Paul A. Rubin, Hydrogeologist

May 5, 2020

## **Surface Hydrology, Hydrogeology, Bluestone Quarries, and Glacial Geology Proximal to Pickerel Pond and the Proposed 850 Route 28 Manufacturing Facility**

Figure 1

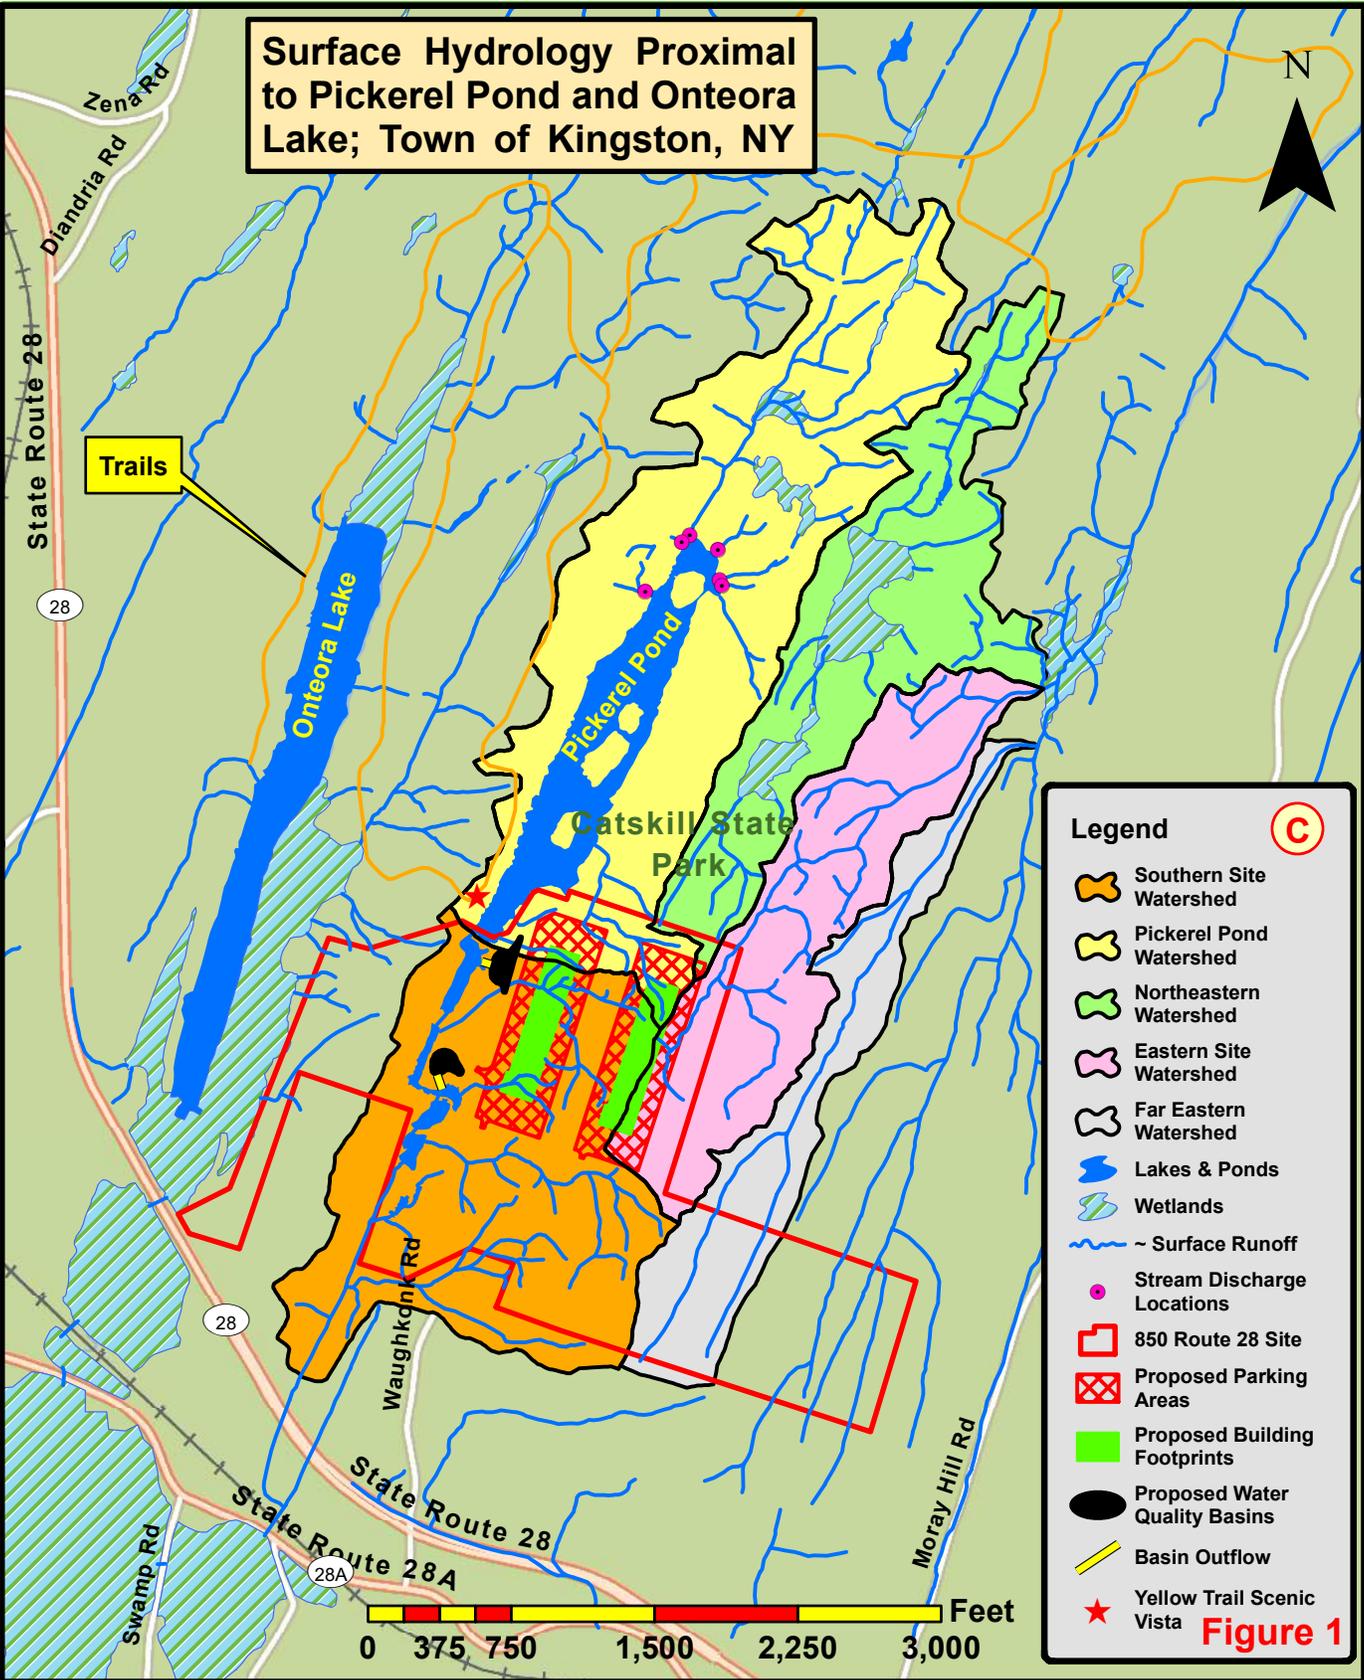
- The proposed 850 Route 28 manufacturing facility straddles a hydrologic divide (see [Figure 1](#)). The southern site, Pickerel Pond, and Onteora Lake watersheds drain southward through a large wetland complex (NYS DEC Wetland KW-3) and then as Praymaher Brook alongside Thielpape Road until flowing into Esopus Creek.
- The northeastern, eastern, and far eastern watersheds drain northeastward as a stream until a confluence with the Sawkill northeast of Jockey Hill. The Sawkill then flows southeastward until it joins the Esopus Creek which then flows northward to Saugerties where it discharges into the Hudson River. The distance along the Sawkill and Esopus Creek between where project site drainage enters them is 10.3 creek miles.

- Figures 1 and 2 show the proposed 850 Route 28 project parking and building areas extending into the Pickerel Pond watershed. Field reconnaissance conducted on March 1, 2020 found only two of six streams actively flowing into the northeastern end of Pickerel Pond. Their combined discharge was estimated as only 25 gallons per minute (Photos 7 and 8). It is highly likely that there is no surface inflow during dry and drought times both here and immediately downstream of the earthen dam. This is important from the perspective of potential dilution and assimilation of chemical contaminants and stormwater runoff that the manufacturing facility may discharge into the waterway. The extreme headwater setting of the proposed industrial facility will, at times, have no natural streamflow.

- While the hydrologic impact to Pickerel Pond would be significant, reference to Figures 1 and 2 reveals that project construction would also result in disruption of surface flow in other watersheds straddling the hydrologic divide discussed above.
- A significant portion of the northern project area was clear cut of trees sometime between 2016 and late 2019, as shown on 9-18-19 Google Earth imagery. This area encompasses both the proposed project site and tributaries to Pickerel Pond. Large felled trees are present within the proposed industrial development area (Photos 9a and 9b). Clear cutting typically results in increased runoff and sediment load and forest fragmentation.

**Figure 2B** Map Date: 5-04-20

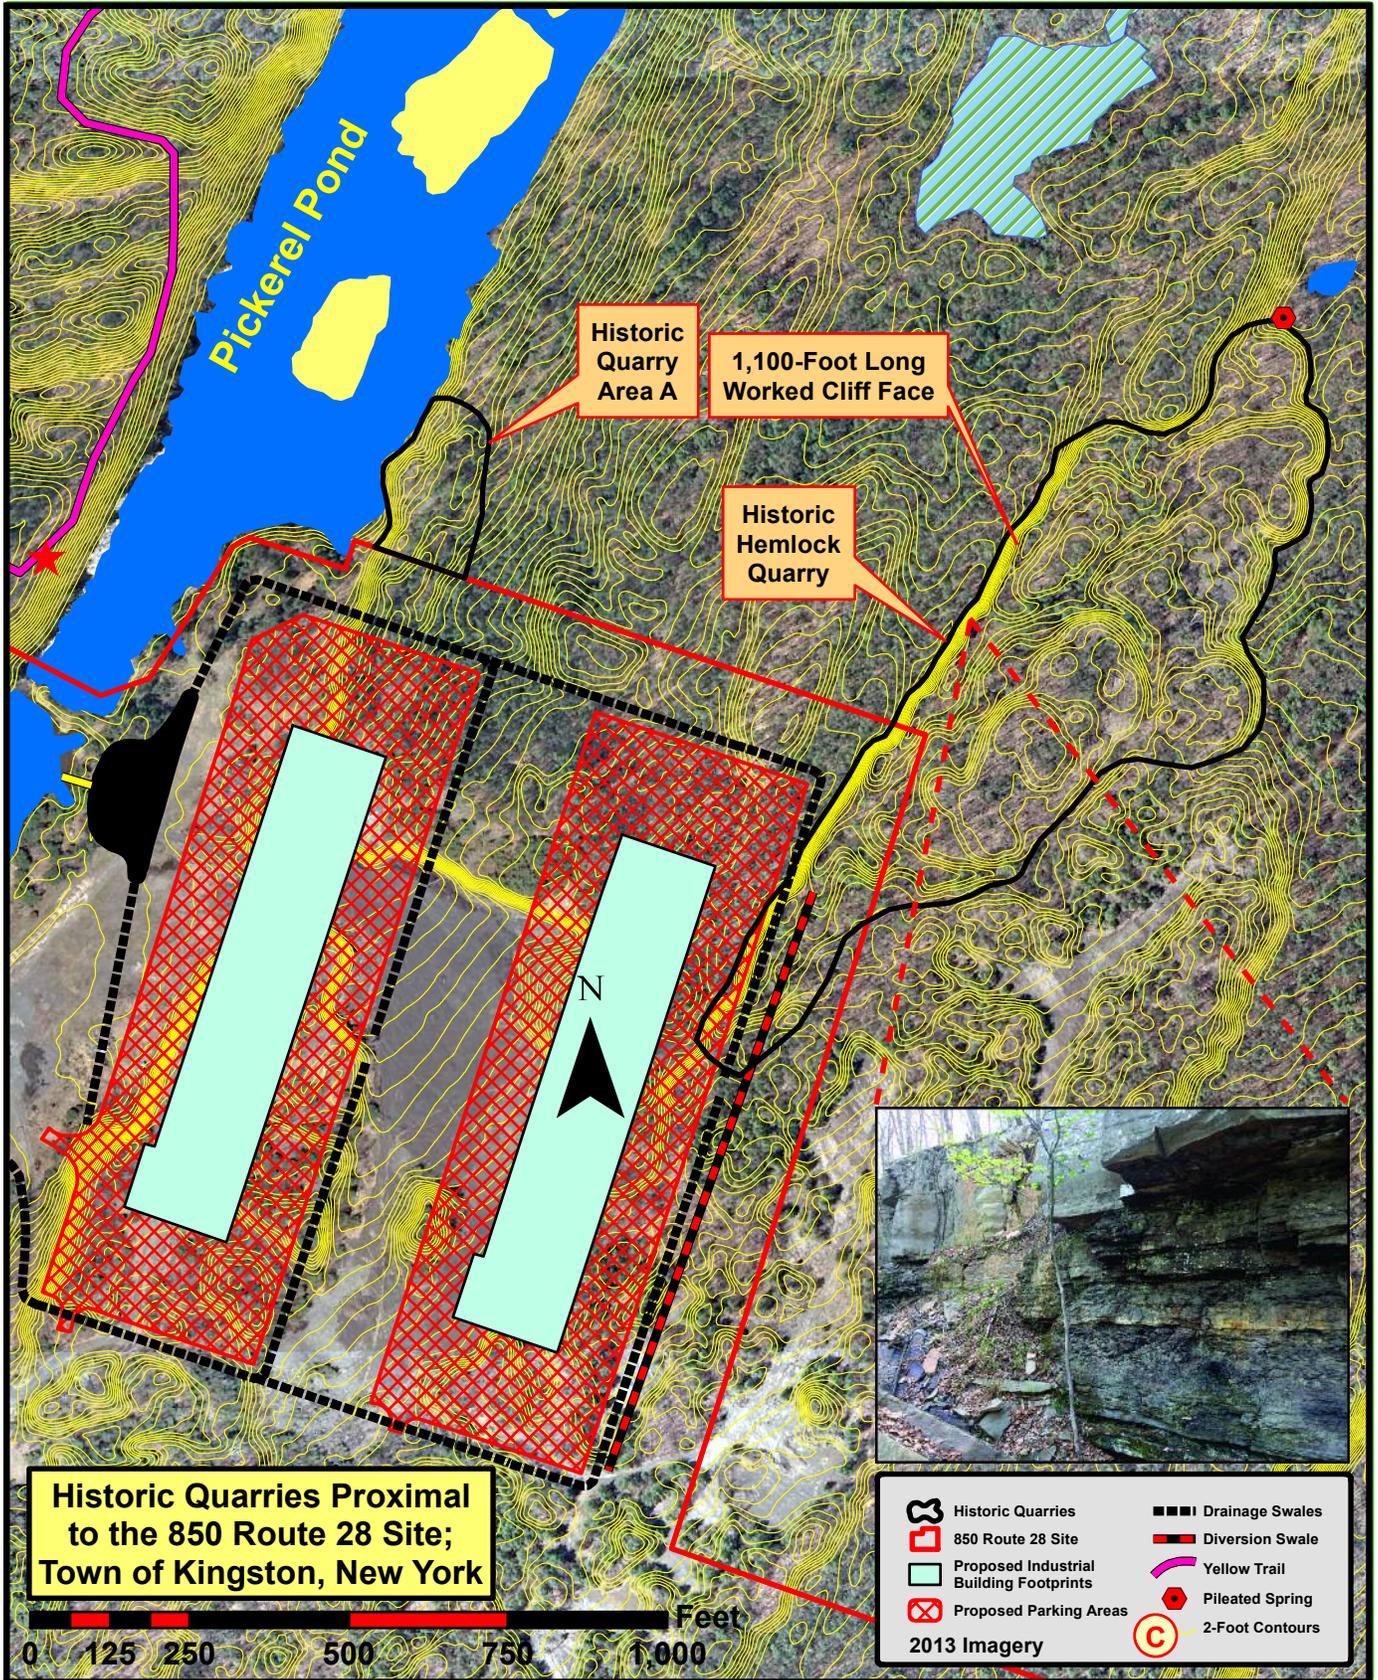
- Historic Quarry area A (Figures 2B, 2C, and 4) extends southward into the proposed project site beyond the property border line depicted. Figure 2B includes a photograph of this quarry area. It is largely comprised low excavated cliff faces and massive quantities of quarry rubble that drape steeply downslope into Pickerel Pond. In one location, a low laid stone wall helps prop up quarry rubble. This quarry area is typical of many of the small bluestone quarry workings along the east and west flanks of Pickerel Pond, as well as elsewhere within the Bluestone Wild Forest. It is likely that any historic quarries that may be present in Quarry Area B will be similar in nature.

- The areal extent of the quarried Hemlock Quarry cliff face is well-approximated on 2013 imagery (Figure 2B) and on a 2-foot elevational map (Figure 2C). Together, they show a linear north-northeast to south-southwest oriented vertical cliff face extending continuously for a distance of approximately 1,100 feet. Photographs on Figures 2B (labeled black linear feature) and 2C show a portion of this worked cliff face. The upper portion of the cliff is comprised of about 10 to 12 feet of massive, bedded, sandstone. Beneath this, some 15 to 20 plus feet of interbedded sandstone, shale, and mudstone provided access to thin sandstone beds sandwiched between weak, easily removed, shale beds. The height of exposed bedrock below the massive sandstone caprock shows that quarrymen sought both the upper massive sandstone layers and lower thin sandstone beds. The presence and exploitation of these lower sandstone and shale beds is not seen elsewhere in the Bluestone Wild Forest.

- Construction of the 850 Route 28 manufacturing facility would irreparably compromise the integrity of Hemlock Quarry. Project plans show that blasting and site grading would occur through the southwestern end of the Hemlock Quarry for construction of a large parking area and diversion and drainage swales (Figure 2C).

Photo 13. Closely spaced and interconnected north-northeast to south-southwest joints, as well as nearly perpendicular joints, extend far below ground surface where they transmit groundwater to streams, lakes, ponds, and wells. Figure 3 shows the location of the red highlighted fractures.

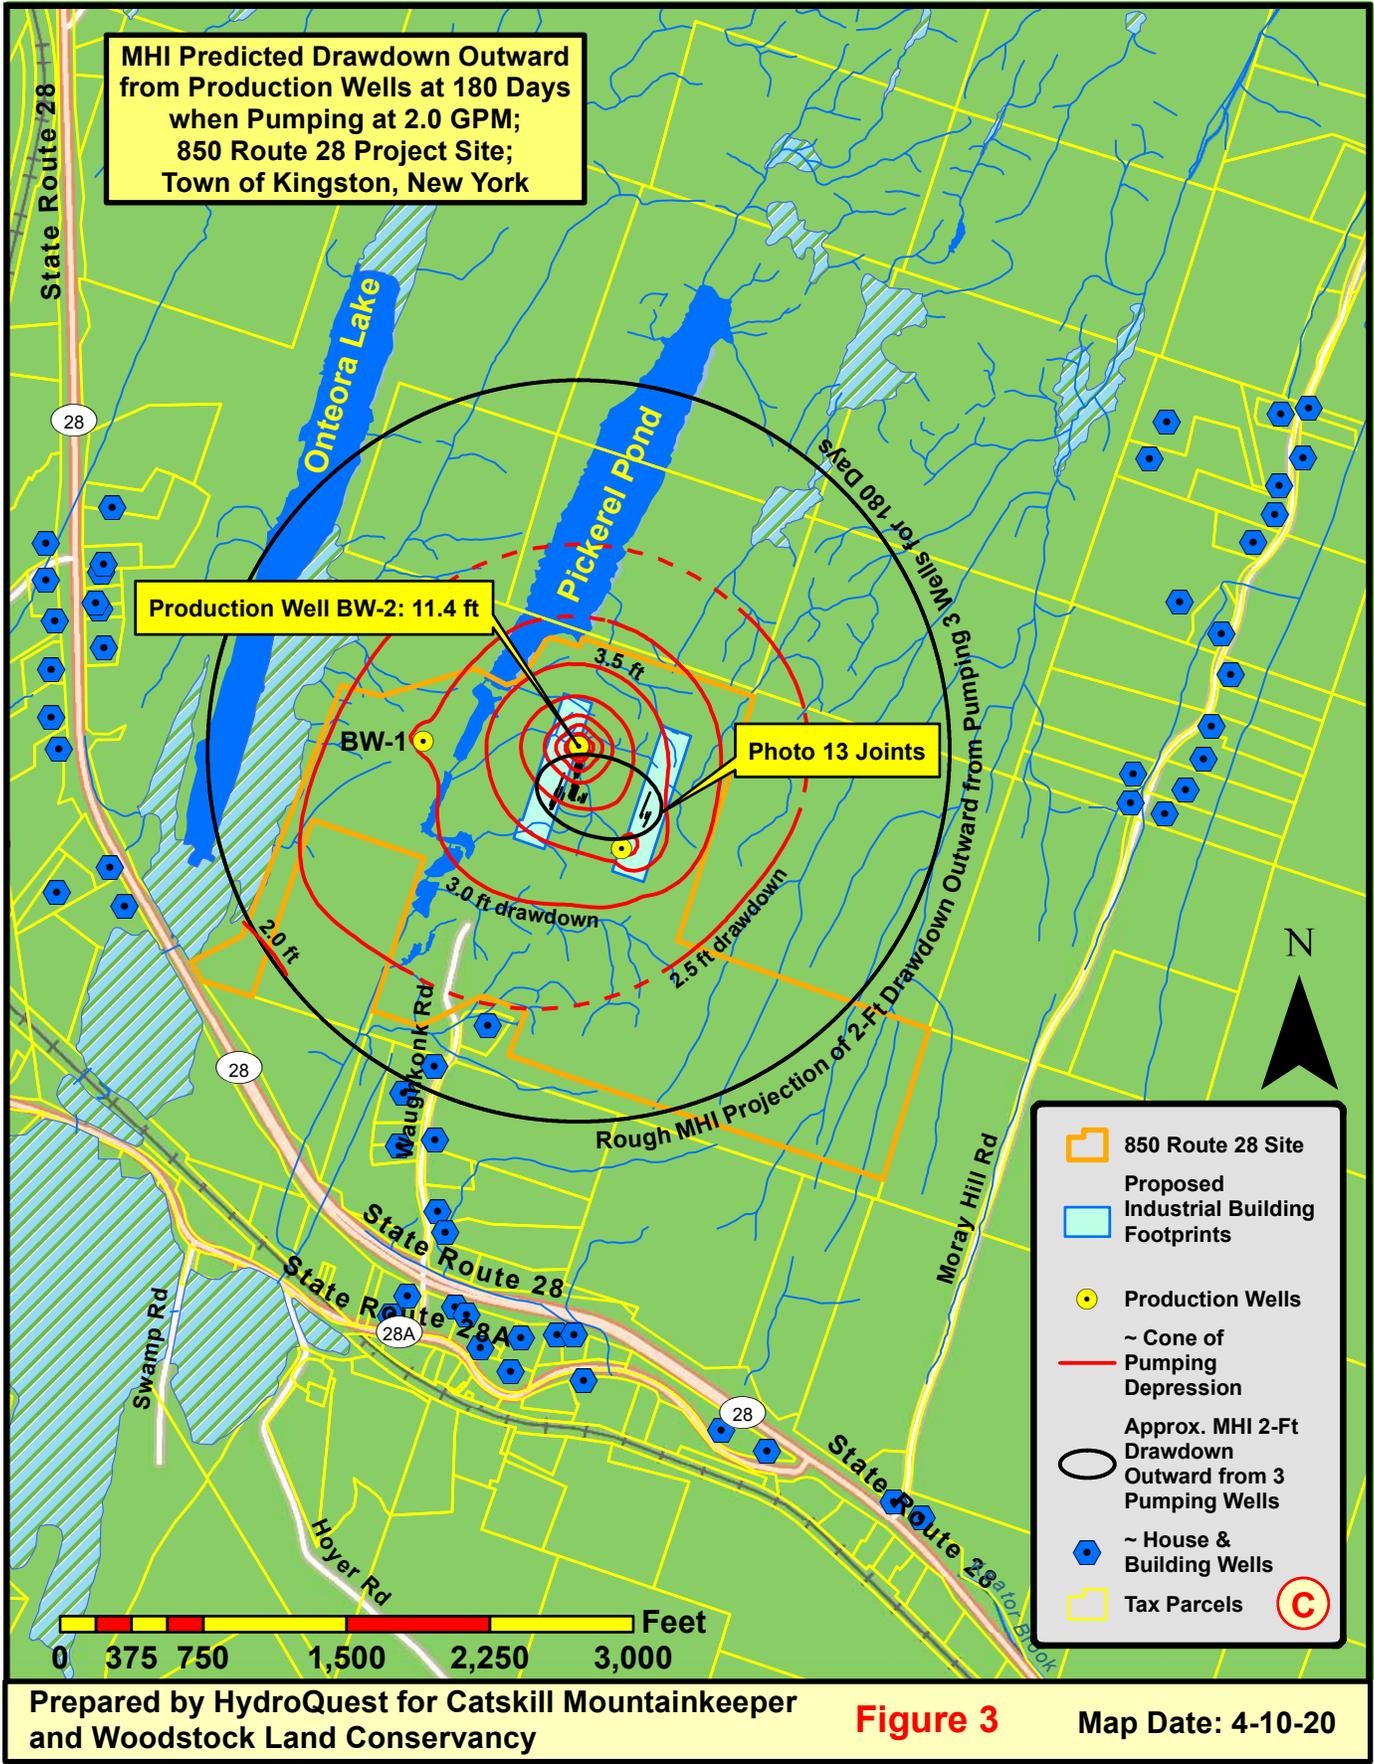
- The Ashokan/Plattekill Formation sandstone and shale bedrock aquifer that Well BW-1 obtains water from is highly fractured (Photos 11 and 12). These photos show planar joints in outcrop exposures close to the project site. Groundwater moves within vertical fractures called joints and along horizontal bedding planes. Vertical joints in the bedrock, visible in 2016, 2013, and 2001 imagery, are highlighted in red on the bottom photograph of Photo 13. They serve as preferential groundwater flow pathways (i.e., secondary porosity). The fractures are closely spaced and very clearly show a preferred north-northeast to south-southwest orientation (N23°E to N27°E), perhaps overlying an unconfined upgradient portion of the bedrock aquifer. Further reference to Photos 11, 12, and 13 reveals cross joints nearly perpendicular to the major joint set (~ N64°W) that interconnect north-northeast (NNE) to south-southwest (SSW) joints.
